Access Compliance Report

Public Rights-of-Way

(Curb Ramps)

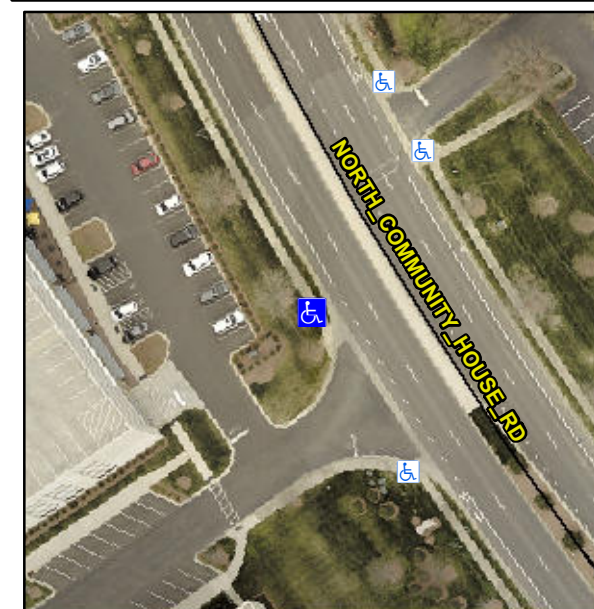
Intersection ID: 10033070	Main Street: NORTH_COMMUNITY_HOUSE_RD	Cross Street: N/A	Location: NW
ADA ID: 6E555BCA4FF1	Ramp Type: Perp	Initial Pass/Fail: Fail	Overall Compliance: No
Codes/Mitigation Info/Possible Solution		Field Measurements/Component Compliance	
Severity Score: 12.5

Not Found, R304.2.2

Remove & Replace Entire Ramp.
